Project	IEEE 802.16 Broadband Wireless Access Working Group < http://ieee802.org/16 >
Title	Enhancement of TRF-IND Signaling
Date Submitted	2004-07-08
Source(s)	Chulsik Yoon, Jaeheung Kim, Kunmin Yeo, Byunghan Ryu csyoon@etri.re.kr <p style="text-align: center;">ETRI 161, Gajeong-dong, Yuseong-Gu, Daejeon, 305-350, Korea</p>
Re:	Contribution on comments to IEEE P802.16e/D3
Abstract	Current TRF-IND signaling gives only a indication for the DL traffic addressed to the positive indicated MSSs. But, during the sleep interval in the mobile environment, the channel characteristics can be greatly changed even in the MSS moving fast and in deep sleep. We propose the enhancement of TRF-IND signaling to applying the appropriate DL Modulation and Coding levels especially for the large amount of DL data buffered MSS.
Purpose	Adoption
Notice	This document has been prepared to assist IEEE 802.16. It is offered as a basis for discussion and is not binding on the contributing individual(s) or organization(s). The material in this document is subject to change in form and content after further study. The contributor(s) reserve(s) the right to add, amend or withdraw material contained herein.

Enhan

Figure 1. Description of the case of the MSS missed the TRF-IND message, but the BS transmitted the DL buffered data.

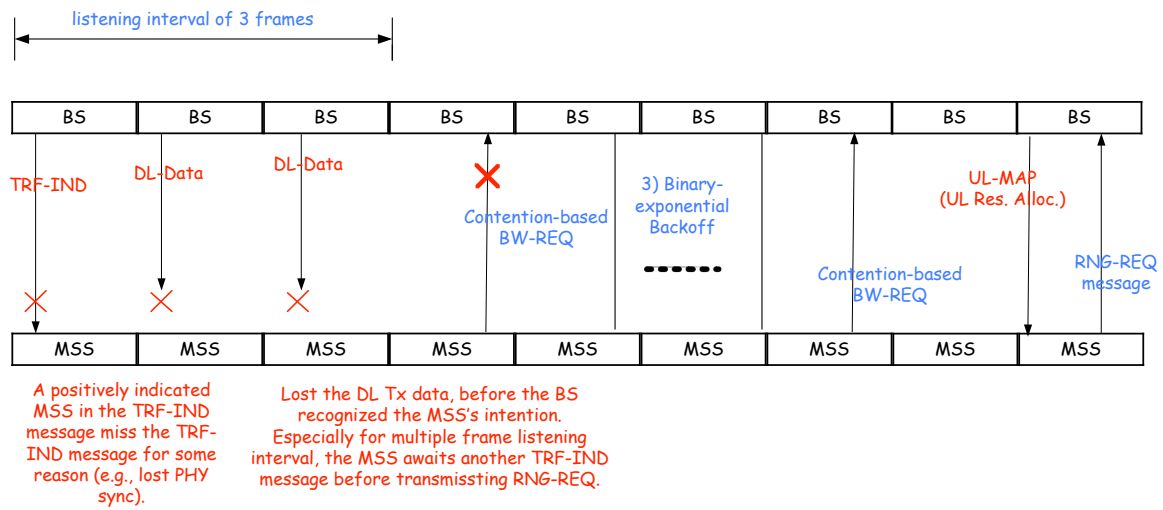
And, the current TRF-IND signaling has no acknowledgement. When the MSS misses the TRF-IND message in the corresponding frame due to a certain reason, the BS can transmit the DL buffered data to the corresponding MSS even during the frame in the listening interval. In that case, the downlink data shall be lost and later be retransmitted after the MSS re-entering to the normal operation states. It also wastes up precious air resources, so we need a resolution to the problem.

We described the problem situation in Figure 1 and Figure 2.

Therefore, we propose to enhance the TRF-IND signaling to resolve this problem with a minimum signaling overheads. We propose to add the indication information for fast UL feedback channel allocation in TRF-IND message for the positively indicated MSS's. For the BS-MSS which is operated in CQI-based mechanism, we can allocate the appropriate CQI channel to the corresponding MSS. And, for the not CQI-based BS-MSS, we can apply the invited ranging interval for the MSS which can report its preferred DIUC.

The MSS which has allocated its fast UL feedback channel or invited ranging interval should respond with its CQI report value or preferred DIUC value to the corresponding BS. Therefore the BS can recognize it as the acknowledgement signal for the TRF-IND message and can transmit the buffered DL data to the MSS with the appropriate DIUC (AMC-level).

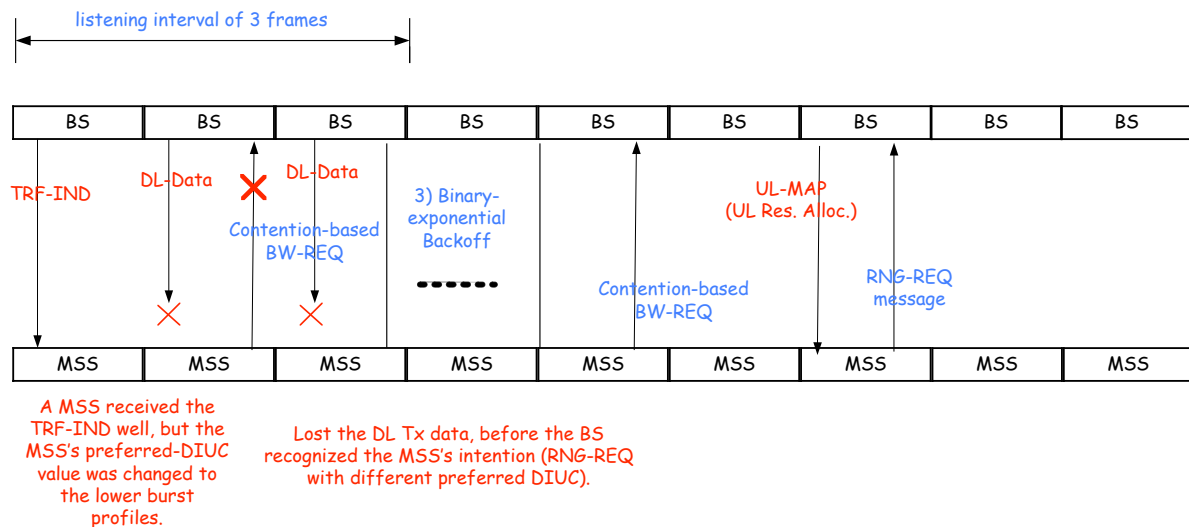
Due to the current P802.16e/D3, the BS may transmit DL buffered data addressed to the sleep mode MSS anytime after the positive TRF-IND signaling. But the MSS's DL channel characteristics (e.g., appropriate DIUC level) can be largely different from that of the sleep mode entering time. If we apply the periodic ranging during the sleep interval instead of it especially reduces power saving efficiency, we can reduce the problem, but not clearly solve them. Generally, the periodic ranging interval have the scale of few hundreds msec. And, during that interval we can adjust the appropriate timing offset due to the movement of the MSS, but it is not possible for power adjustment correctly. Since the coherence time is the order of up to few msec even in the pedestrian speed, so we cannot guarantee that we can apply the same DIUC adjusted in the last periodic ranging event at the midst of the periodic ranging interval. (*Coherence time has the time of meaning of the channel condition is the same, which have the difference in the SNR value is less than 3 dB. Remember that the difference in the neighboring DIUC levels is about to 3dB or less.*) But, the shorter time interval as the periodic ranging gives us more signaling overheads and it reduces system performance.

Figure 2. Description of the case of the MSS received the TRF-IND message well, but the DIUC mismatch occurred during the DL data transfer between the BS and the MSS. For prohibiting the case, the BS can transmit the DL buffered data using the most robust DL burst profile, but it will possibly wasted up the precious air resources. Therefore, large sized buffered data should be transmitted after the BS acquires the MSS's best DIUC level.
